**LEXINGTON-FAYETTE URBAN COUNTY GOVERNMENT  
CONTRACT CHANGE ORDER**  
Page 1 of 2

Date:	October 30, 2015
Project:	Public Safety Operations Center Phase 1B Renovation
Location:	115 Cisco Road
Contract No.	287-2014
Original Contract Amt.	\$6,109,000.00
Cumulative Amount of Previous Change Orders	\$275,553.54
Percent Change - Previous Change Orders	4.51%
Total Contract Amount Prior to this Change Order	\$6,384,553.54
Change Order No.	7

CHANGE ORDER: 7

**SITE UTILITY PLAN**  
**LFUCG PUBLIC SAFETY OPERATIONS CENTER**  
**PHASE 1B - RENOVATION**

**C1.2**

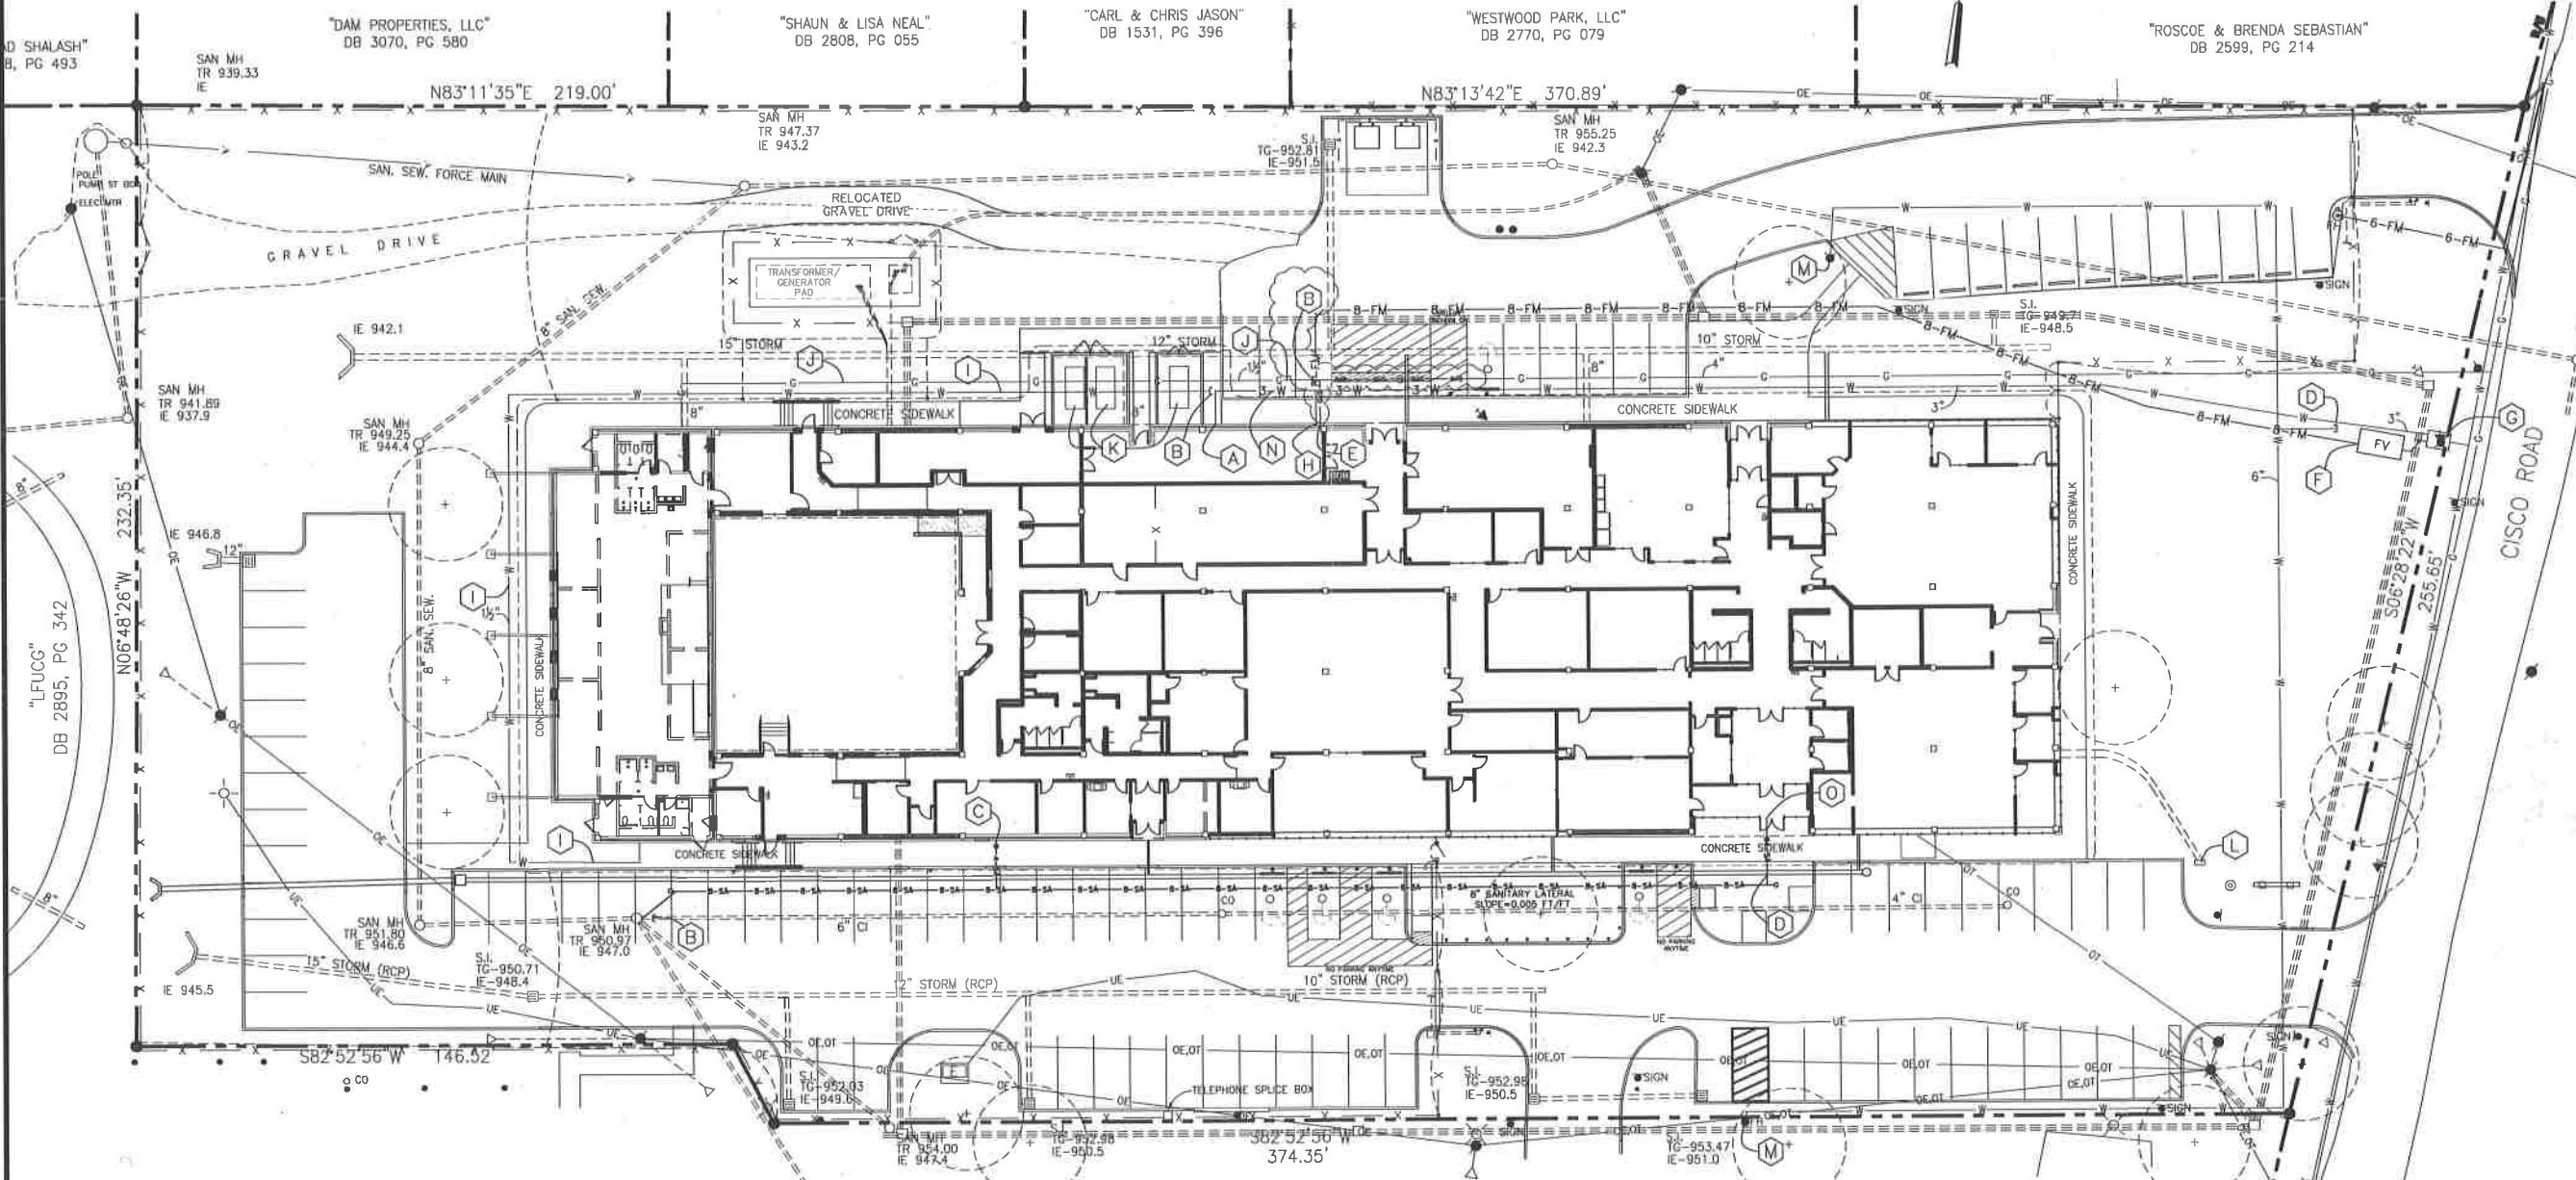
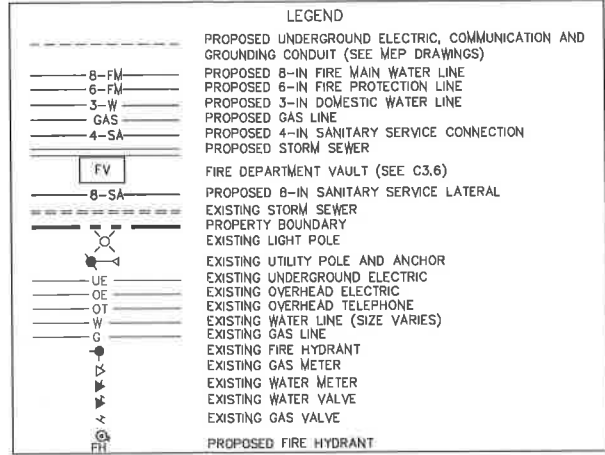
Per the attached revised utility plan. Contractor shall install a 2 ½" gas line; extended from the building to the connection point where the existing 4" gas main ends. This is approximately 40' from where the gas line enters into the building.

- (E) CONTRACTOR TO INSTALL NEW 2 1/2" GAS LINE FROM RISER LOCATION TO EXISTING 4" LINE. (SEE MECHANICAL DRAWINGS FOR CONTINUATION INTO BUILDING)
  - (F) USE A 6x8 REDUCED TO UPSIZE FIRE LINE TO 6-INCH

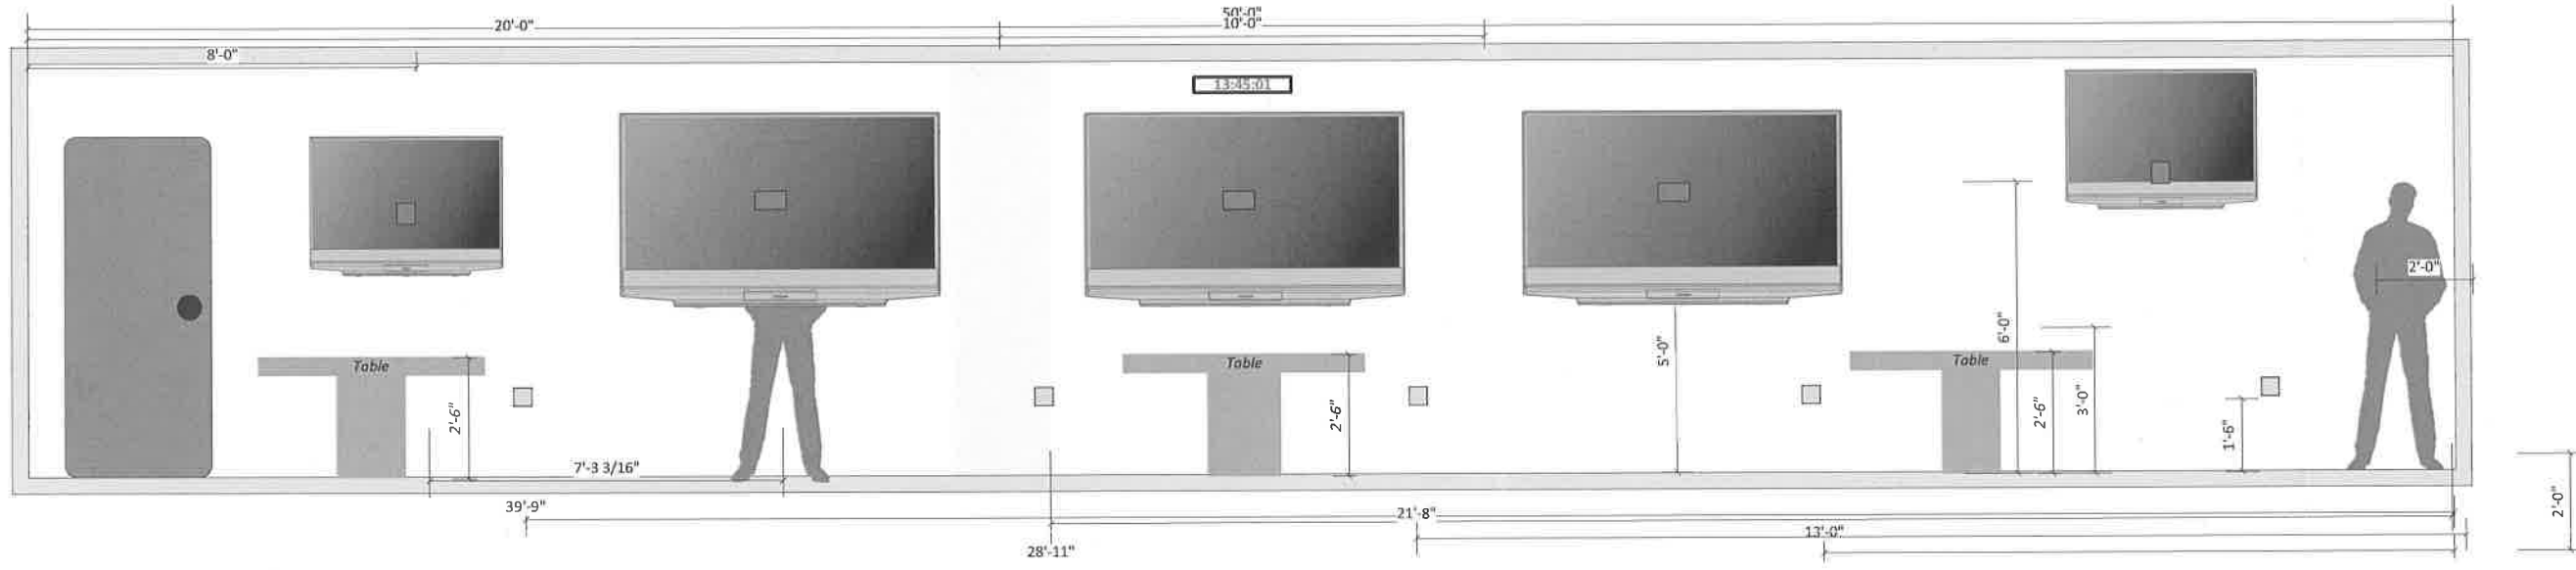
We have started pulling cable in the IDF area. A few questions that have come up: From ESI 24- the rooms and drops being served by the new IDF had a few errors – Room 104 is a restroom, should read 105, and Room 111 has 2V/2D that were left off. Total count should be 51V/51D, with 5 TV, 1 clock, 1 WAP. There is a camera on the outside corner of Room 109. Will the camera also land in IDF 111? Can the cabling from Rooms 112, 113, 114, 116A, 116B also be ran to new IDF? There looks to be 70V/70D, plus 2 WAP, 10 TV, 3 clocks, 2 cameras. In the MDF, we have 2 cabinets for Data, 2 for Voice, last cabinet in that row is Audio Visual. Where will the 'TV' drops land? Camera Drops? Clock drops?

Instructions are to furnish and install a 12 strand fiber from rack in the Communication Room to new Owner furnished wall rack. Is the rack in the communications room to be one of the data cabinets, or another cabinet?
